Certificate of Appropriateness

2443 N. TERRACE AV. **Property**

North Point North HD

Description of work Replace existing fence pet attached description.

Location of existing fence to be replaced (in identical location)

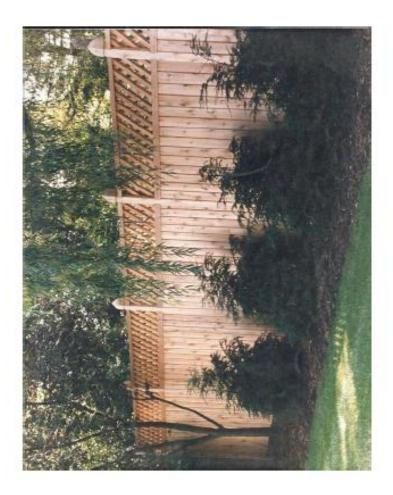
Style is acceptable, fence must be painted or stained and not left as bare wood.
